**SUMMER VILLAGE OF BIRCHCLIFF
SUBDIVISION AND DEVELOPMENT APPEAL BOARD AGENDA
DENIAL OF DEVELOPMENT PERMIT FOR LANDSCAPING
REVISIONS/MECHANIZED EXCAVATION ON THE ESCARPMENT
JULY 11, 2023 @ 10:00 a.m.**

71 Birchcliff Road (Lot 2, Block 4, Plan 4486AX)

Re: Development Permit #211304 Landscaping/Mechanized Excavation
Amendment Application at 71 Birchcliff Road (Revised Plan)

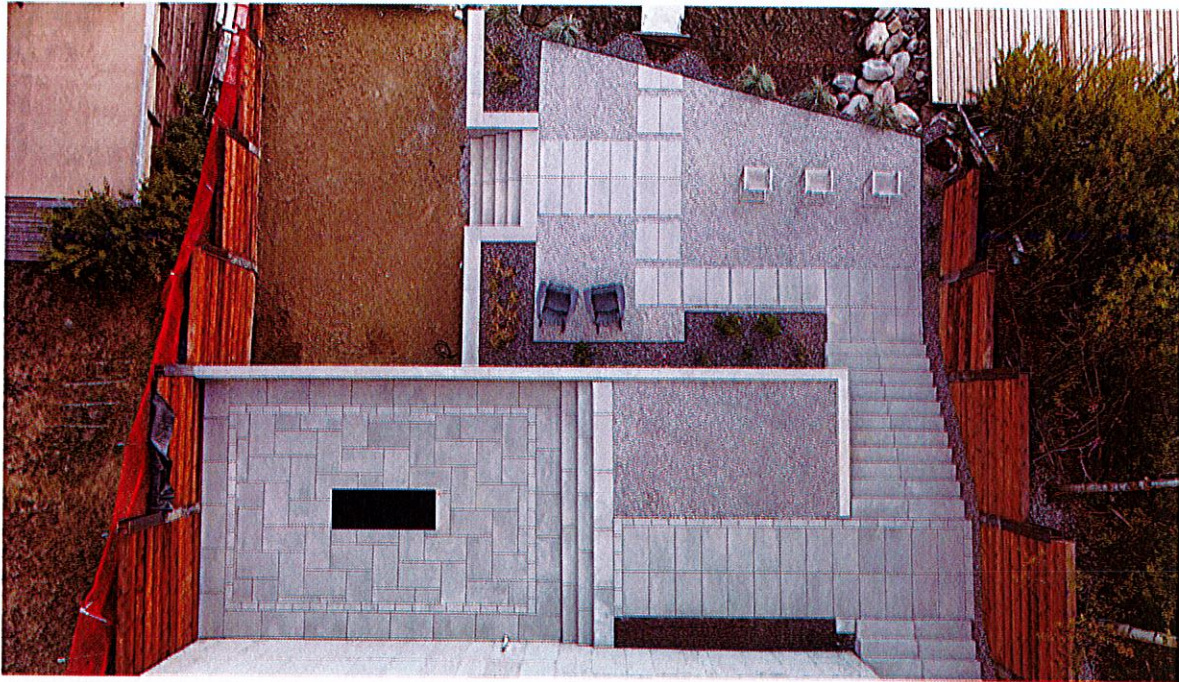
To better understand which areas we are discussing I have labeled them for discussion purposes.

Tier 1 (Lower). This is the boat lift/dock storage area. The approved permit indicates that *"The entire lowest tier adjacent to the lake to be a no mow zone of native grasses and shrubbery, no beach or sandy area permitted"*. This area will be a no mow zone and left to naturally revegetate.

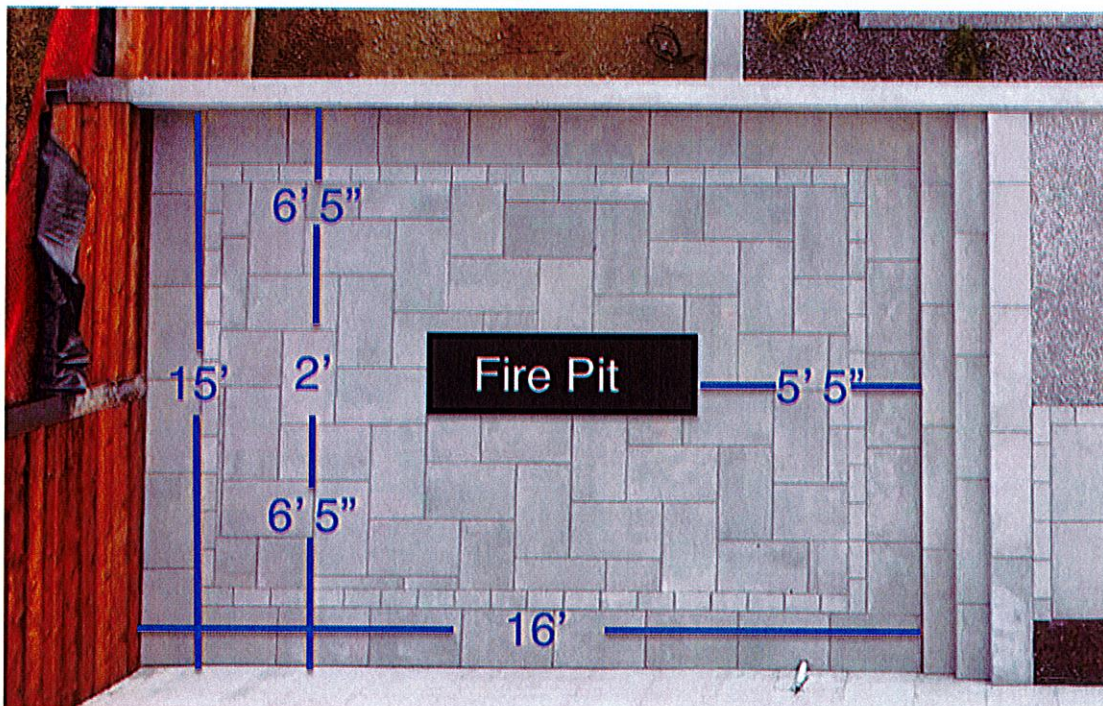
Tier 1 (Upper) This tier has a combination of paving stones and natural rundle stone. The pavers serve as a walk way from the stairs to access the dock and the dock/lift storage area. We have elderly parents that spend a lot of time with us and require accessible access to the lake. We planted 32 shrubs and grasses on the perimeter of this tier. Natural vegetation can also grow in the areas amongst the rundle rock.

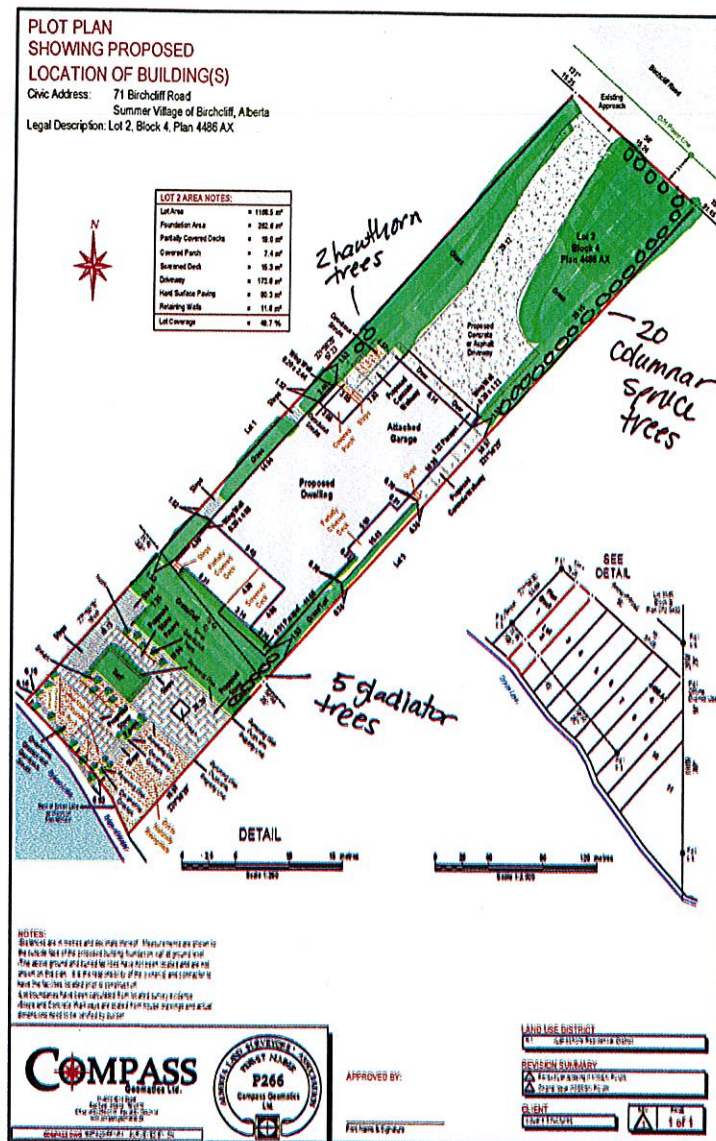
Tier 2 This tier is a combination of a lowered fire pit area and a turfed lounging area. The fire pit area was recessed 2' for protection from the wind. The size of the wood burning fire pit is approx 2' x 4'. Permeable paving stones were installed surrounding the fire pit as per the National Fire Code which states that a 2 meter stone perimeter is a safe flame protective perimeter.

The lounging area of Tier 2 includes stone pavers that access the fire pit area, a turfed area for lounge chairs and perimeter planting of 5 shrubs.

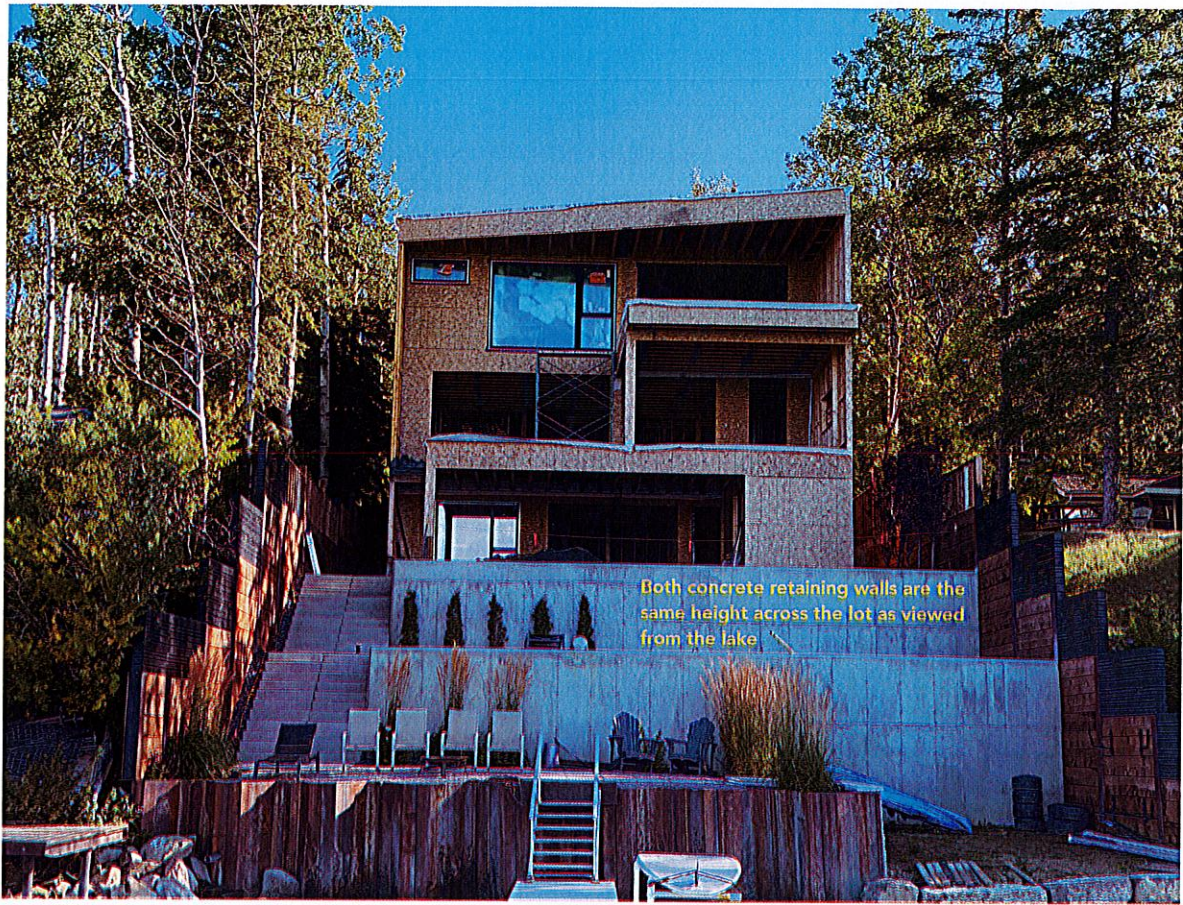
The only other item that was mis interpreted after the first application was the heights of the retaining walls. All the concrete retaining walls are 2 meters in height with the exception of the boat lift/dock storage area (shown on the original plan) and the new fire pit area on tier 2. As the fire pit area was recessed within the original concrete walls, the height is 2.4m. However when looking at the lot from the lake view you cannot see this difference in height. See the pic below.

Constructed

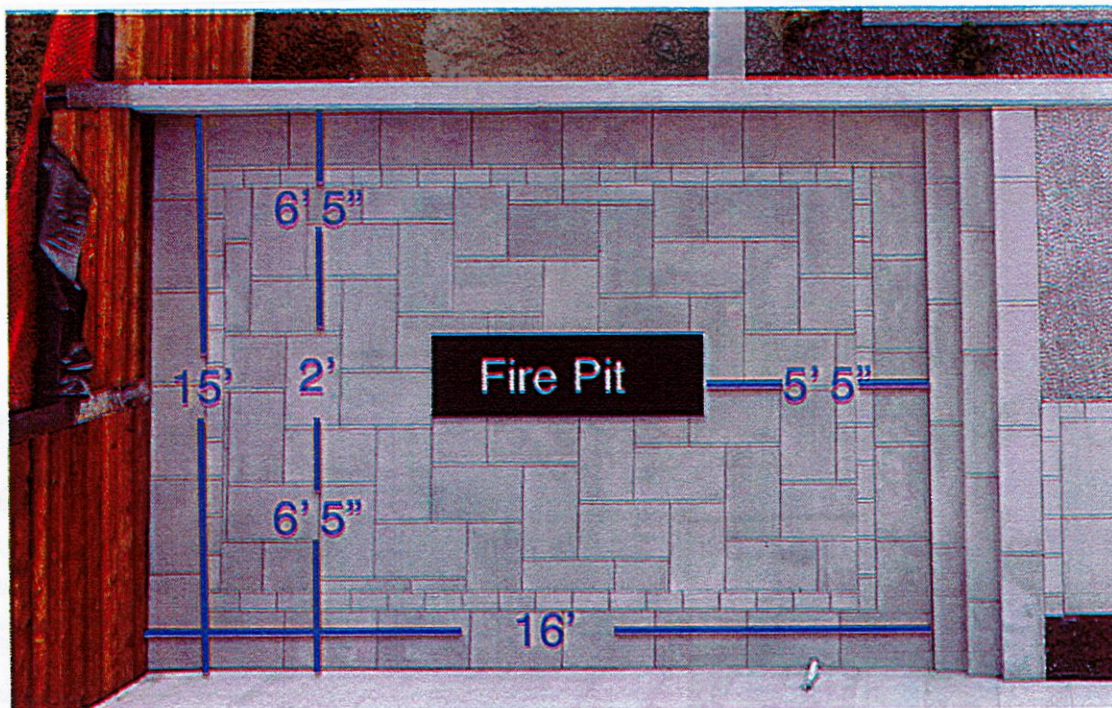
On October 6, 2021, a site inspection was completed, it was found that the landscaping was not complete in accordance with the approved plans. It was found that the landscaping constructed was very unlike the approved landscaping plans, with the majority of the escarpment area covered in hard landscaping. The firepit area had also been relocated, expanded, and lowered, meaning one of the sections of retaining wall measures at 2.4m (7.87ft.) and is exceeding the approved 2m (6.56ft.).

Location retaining wall exceeds maximum

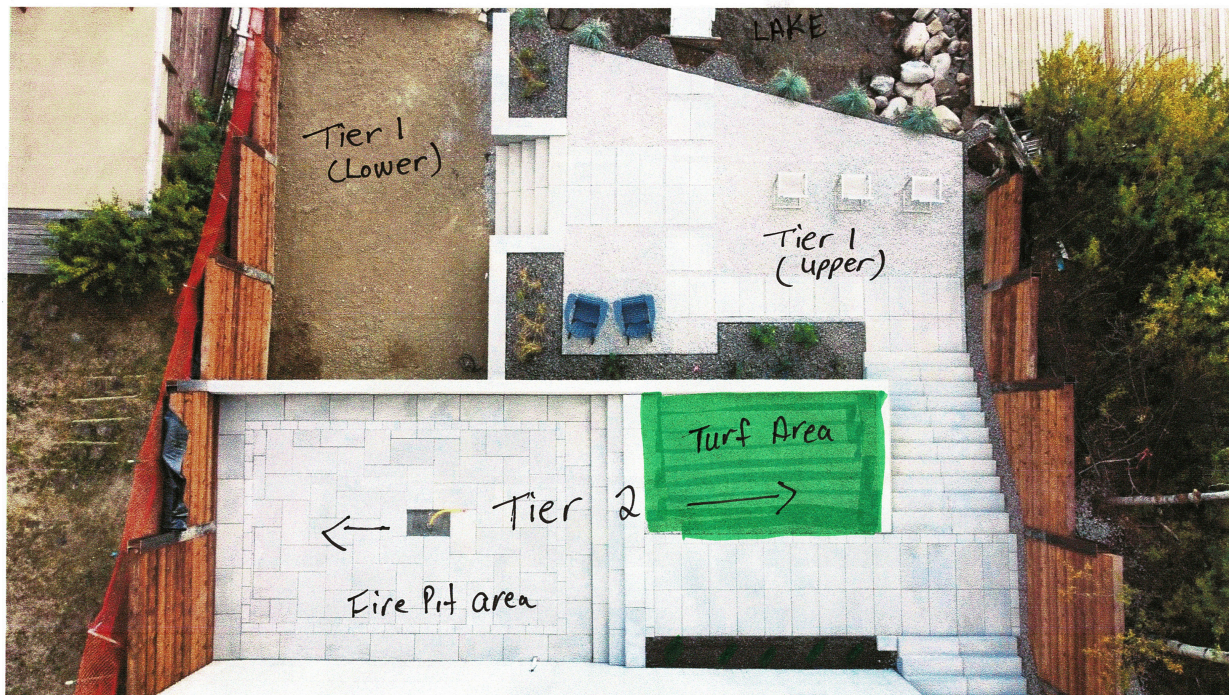
- 1) Leave existing pathway pavers in place to access the fire pit, on tier 2 and path to boat dock and boat storage. Pavers are noted on the geotechnical report as permitted on the escarpment.
- 2) We will remove the rundle rock on upper Tier 1 if absolutely necessary and plant grass, however we have no way of watering the grass and due to it being south facing it will not grow well. Also indicated on the Geotechnical report automatic sprinklers are prohibited.
- 3) We will not backfill the fireplace area to raise it up to the height of the rest of tier 2. This is physically impossible and will not change the look of the landscaping to natural as requested by MPC. We will however remove some of the pavers around the fire pit area and plant grass.

Constructed

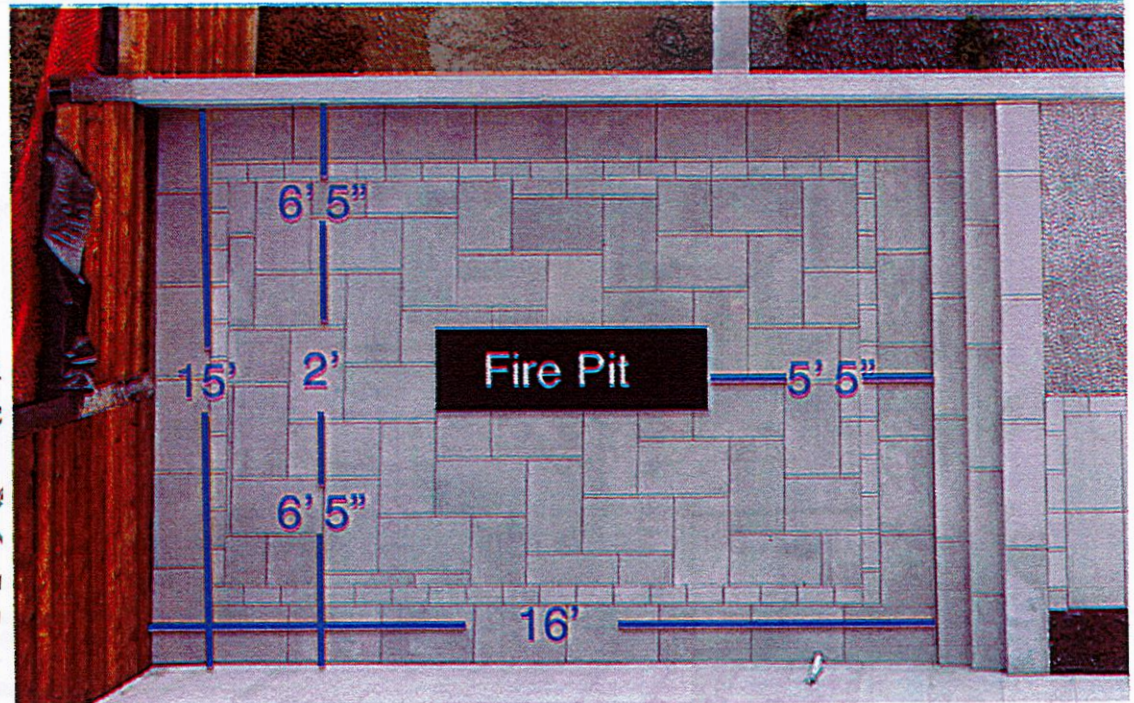
Location retaining wall exceeds maximum

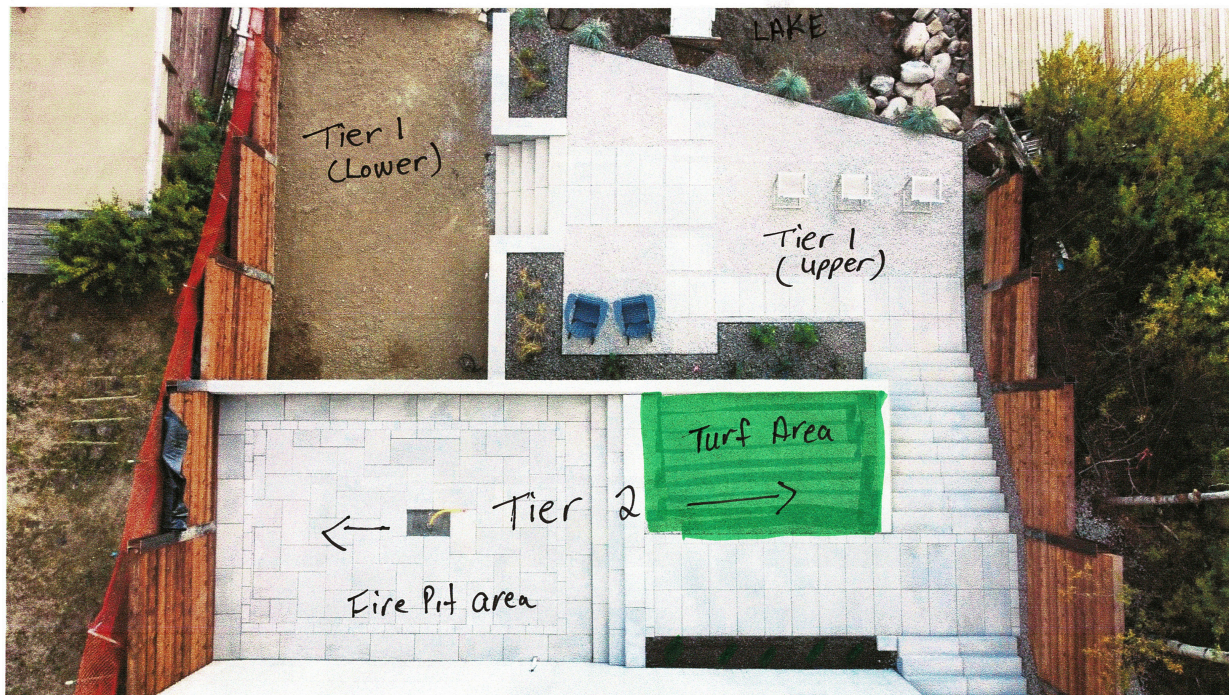
- 1) Leave existing pathway pavers in place to access the fire pit, on tier 2 and path to boat dock and boat storage. Pavers are noted on the geotechnical report as permitted on the escarpment.
- 2) We will remove the rundle rock on upper Tier 1 if absolutely necessary and plant grass, however we have no way of watering the grass and due to it being south facing it will not grow well. Also indicated on the Geotechnical report automatic sprinklers are prohibited.
- 3) We will not backfill the fireplace area to raise it up to the height of the rest of tier 2. This is physically impossible and will not change the look of the landscaping to natural as requested by MPC. We will however remove some of the pavers around the fire pit area and plant grass.
